RE: Initial Submission Review – Kings Point South PAS 1-4 – Site Plan
and Plat Application Number: DA-1628-06
Case Numbers: 2022-4037-00, 2022-3063-00

This letter is in response to the City of Aurora's comments dated August 26, 2022. Comment responses are shown in *red*.

KINGS POINT SOUTH - PA 1-4

TYPICAL 23' PRIVATE DRIVEWAY

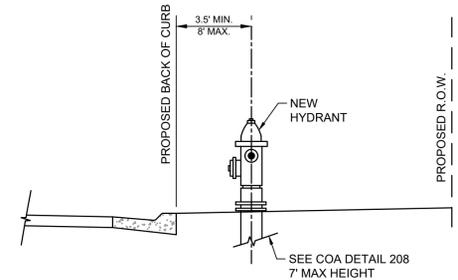
26' if parallel utilities per section 5 of Aurora Water standards

Comment addressed. This detail the site plan sheets and that plat have been modified to show 26' Utility & Access Easement

TYPICAL FIRE HYDRANT PLACEMENT

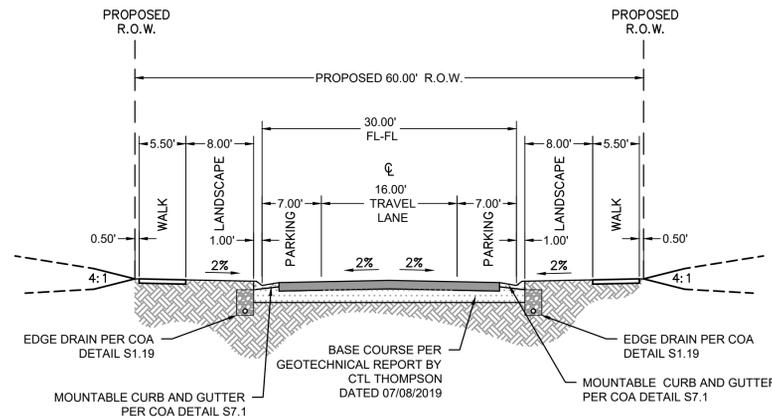
Include the fixture type and pole height for the required public streetlights.

Fixture types and pole heights will be included in the CDs

SHEET NUMBER
 SP1

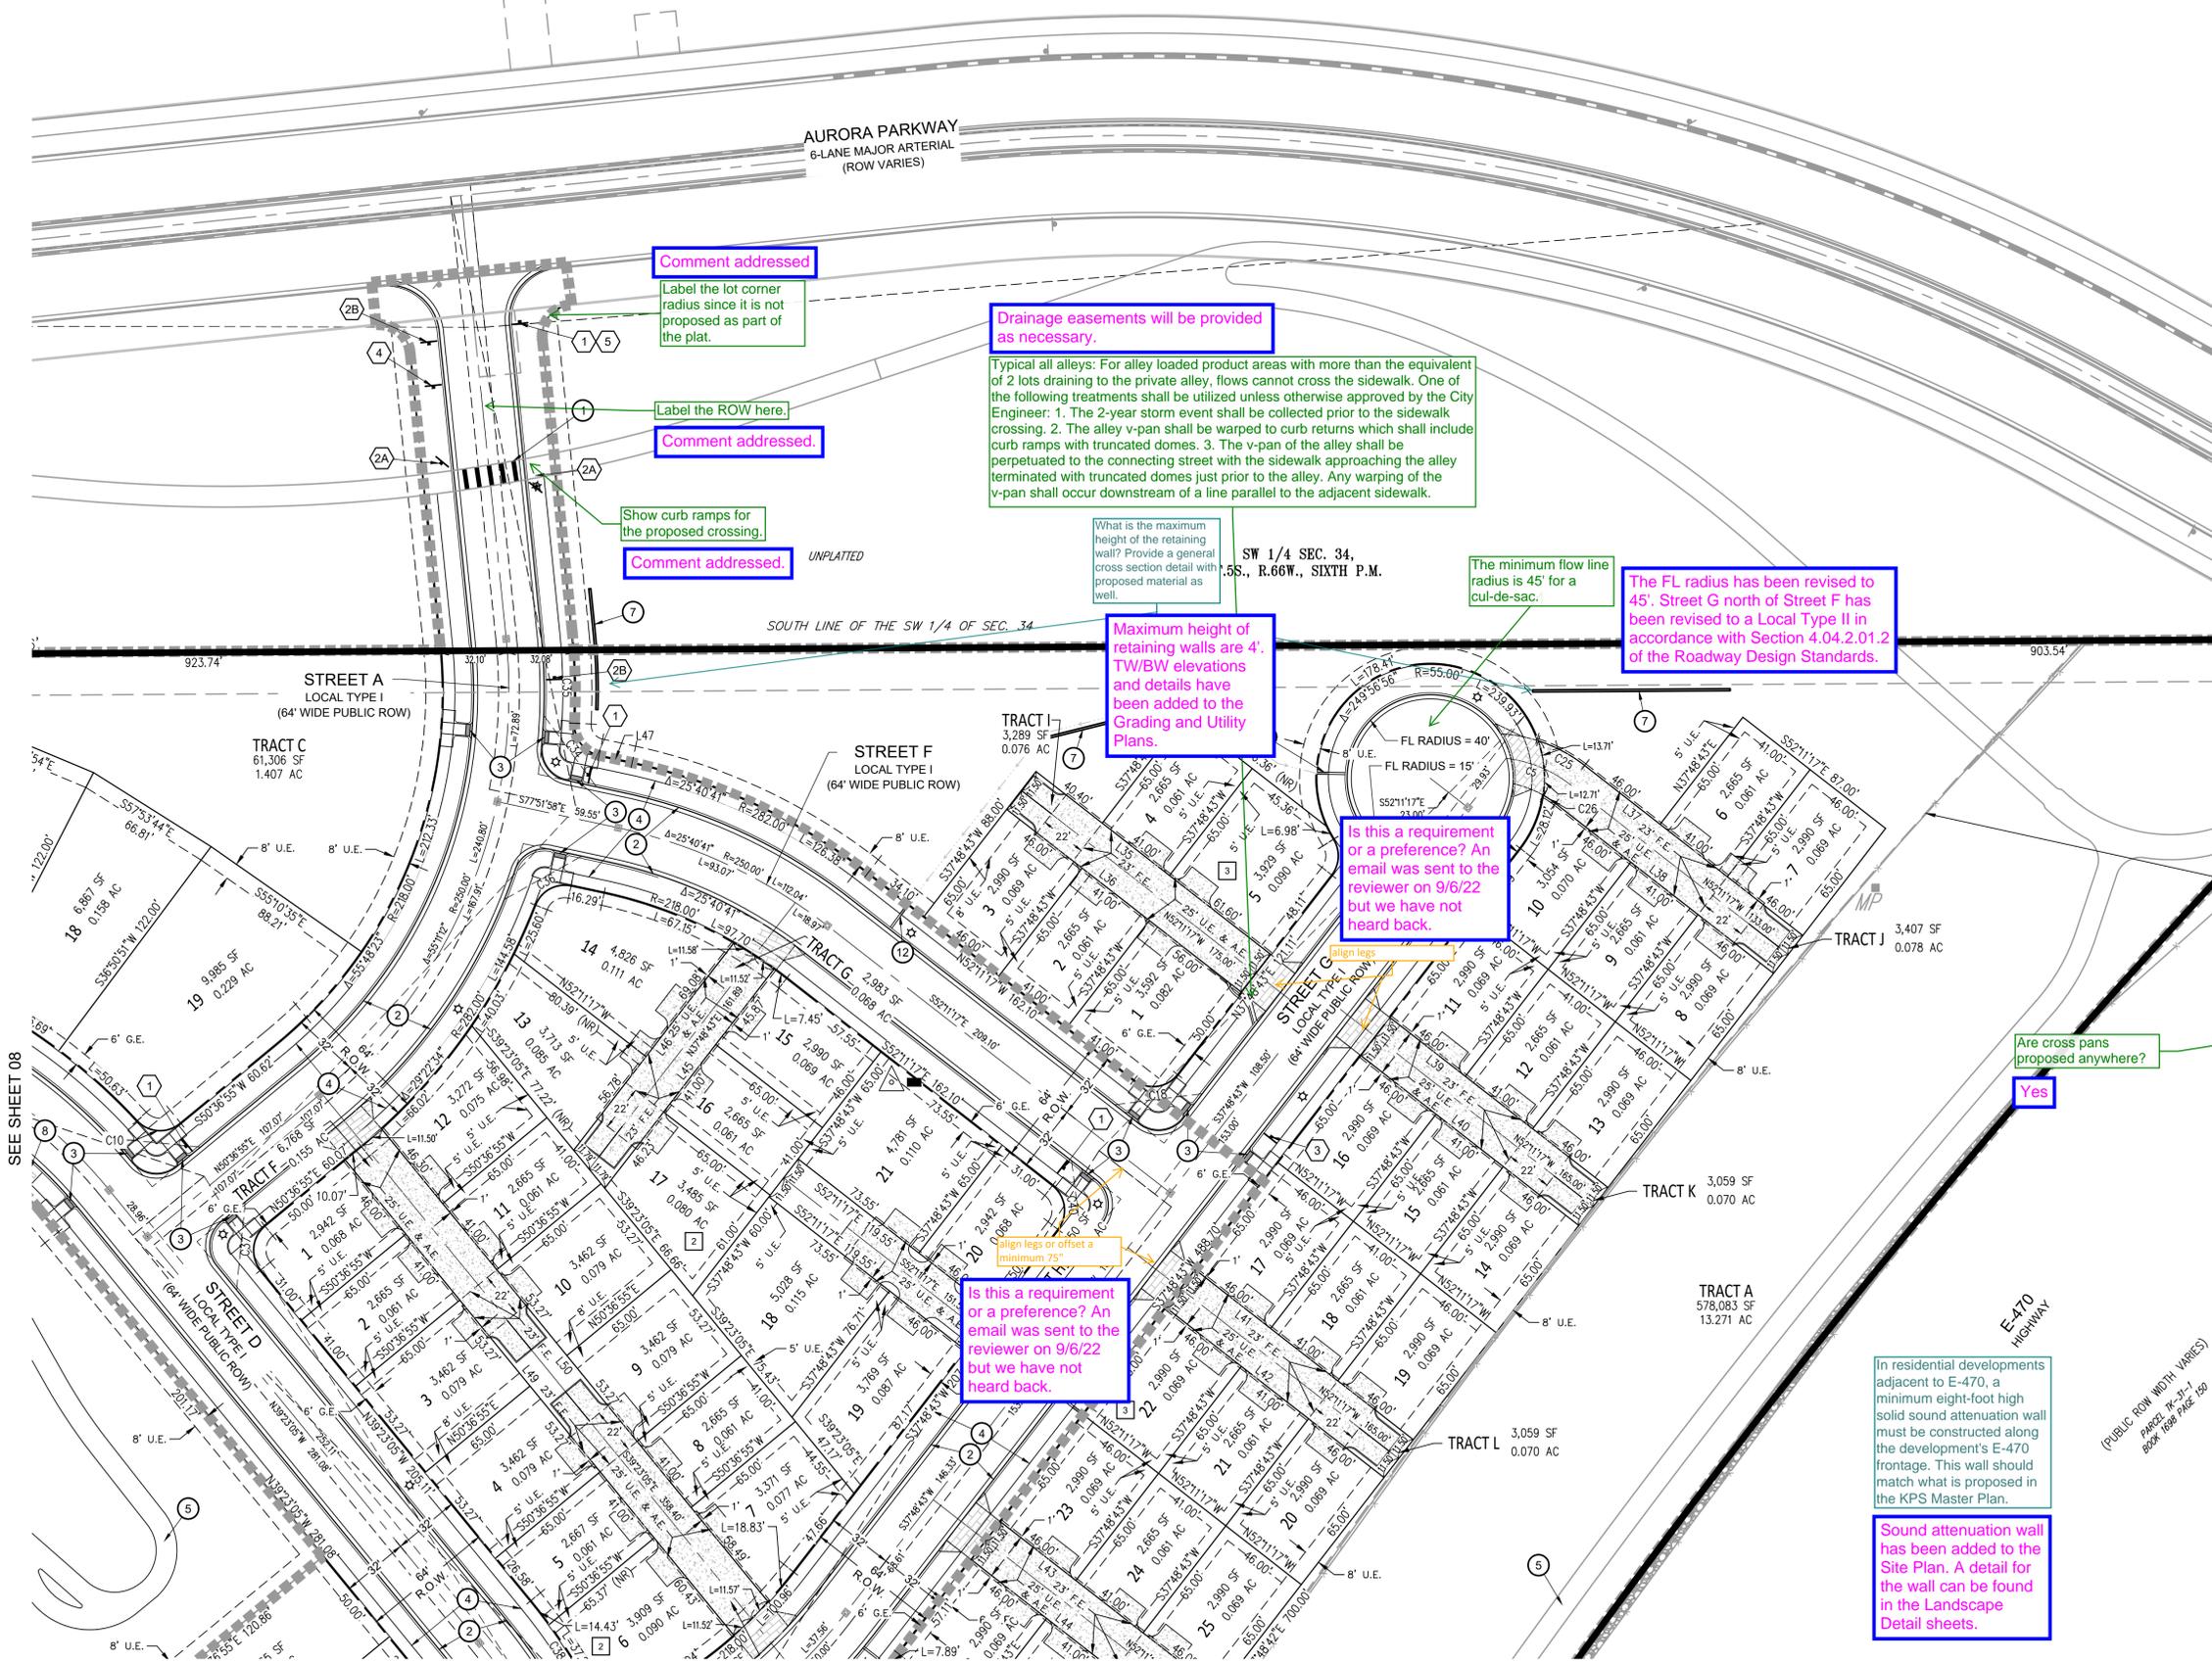
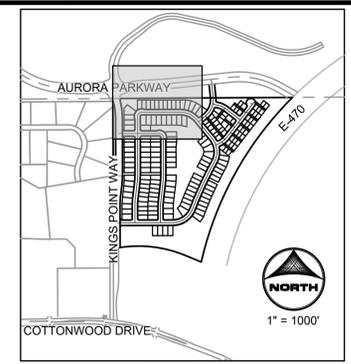
- The tract width must be 30 ft to break up the block length. *Tract widened to 30 feet. Site Plan annotation and Lot Area Table have been revised accordingly.*

Tract width must be 30 ft to break up the block length

FL-FL dimensions added to the site plan sheets

Tract widened to 30 feet. Site Plan annotation and Lot Area Table have been revised accordingly.

Kings Point way is already constructed. It is an existing street.

SHEET NUMBER
GUP1
 SHEET 15 OF 33
 PROJECT NO. xxx

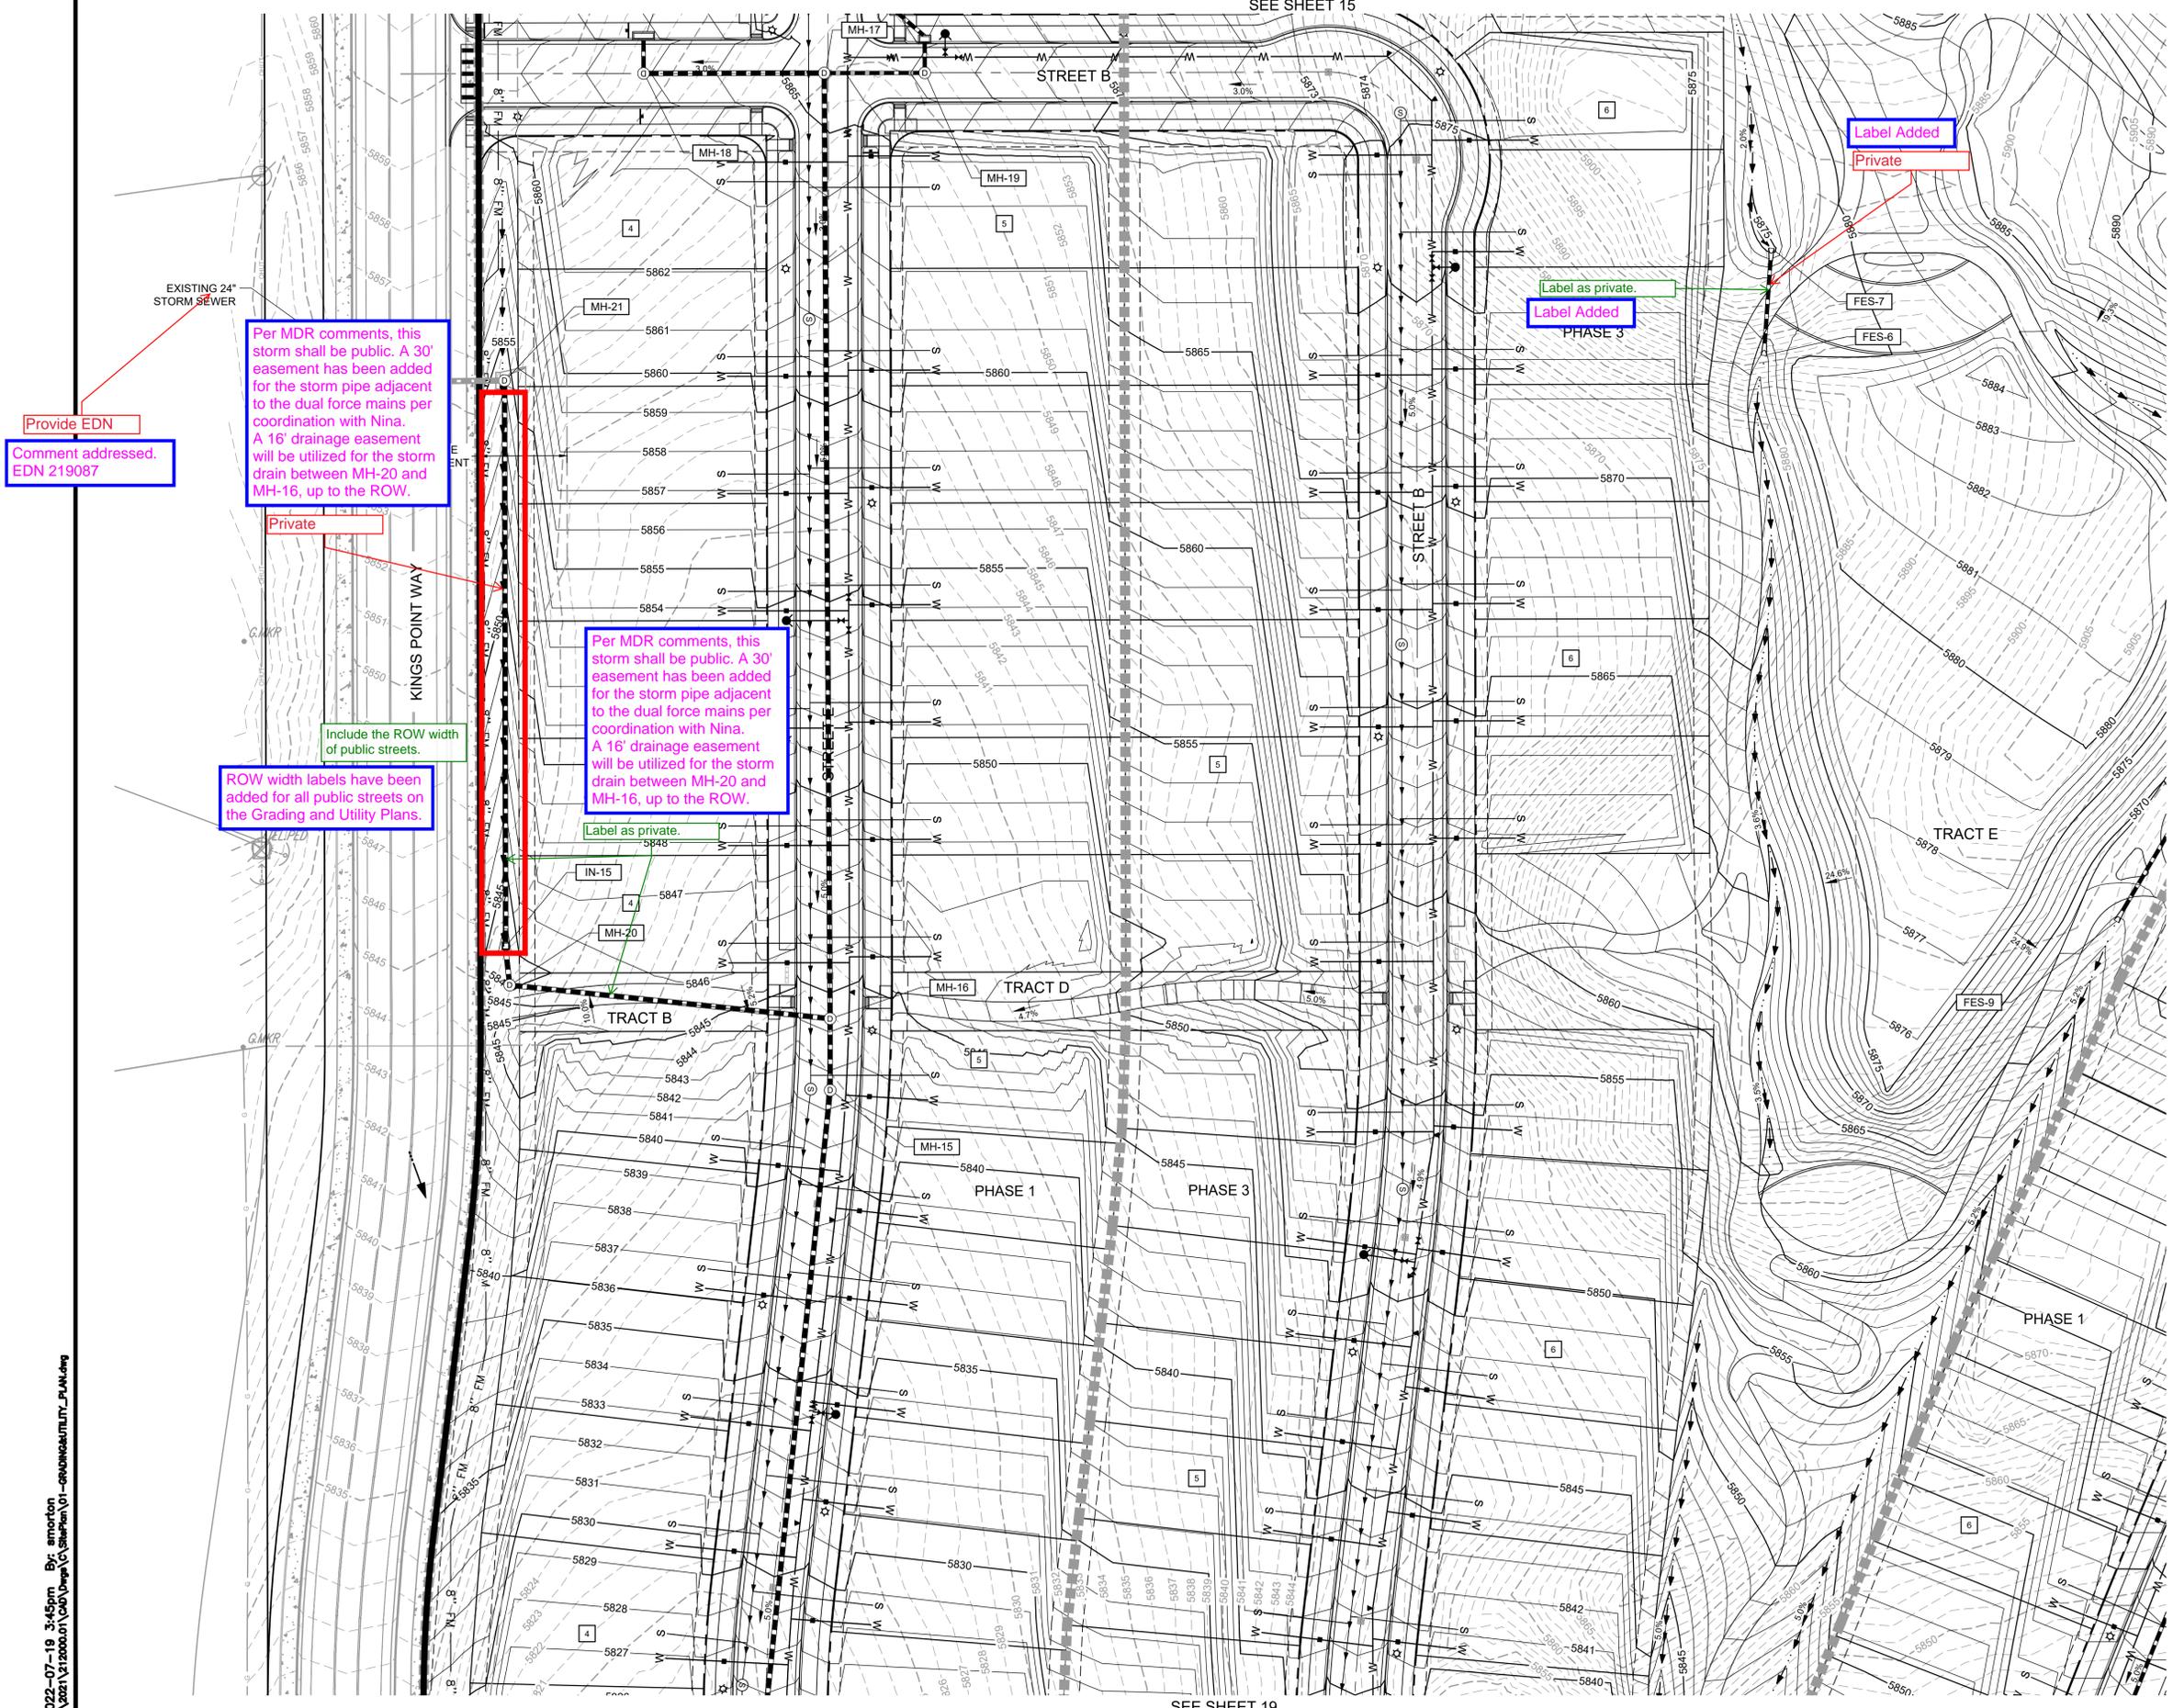
Is there a swale proposed here? Label the slope if so.

Retaining wall details and typical sections are provided on sheet GUP-6.

Yes, there is a proposed swale with a 2.4% slope. Labels added accordingly

SHEET NUMBER
L-8
 SHEET 28 OF 33
 PROJECT NO. 8677-000

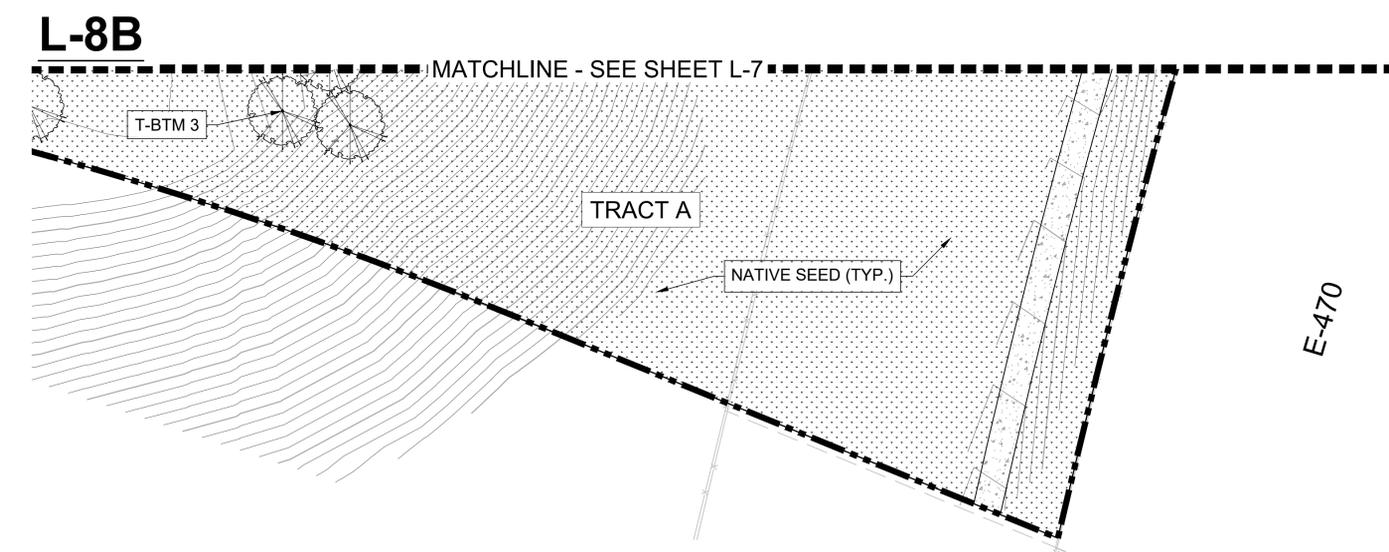
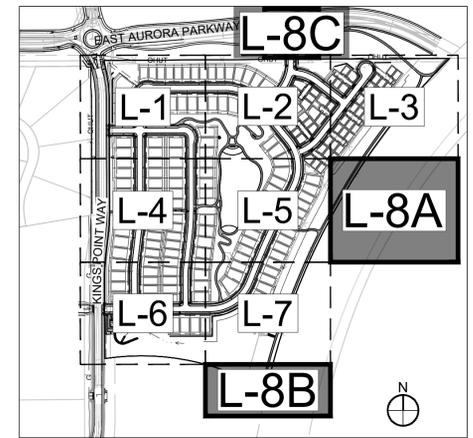
- Please explain why no curbside landscaping is shown in this area since there are street trees shown. *Street is off of our property. Street trees and native seed have been added. No curbside landscape because there is no sidewalk in this area. Assume that Kings Point North (Painted Prairie) is landscaping this tract with their submissions.*

Landscape Added
Please explain why no curbside landscaping is shown in this area since there are street trees shown.
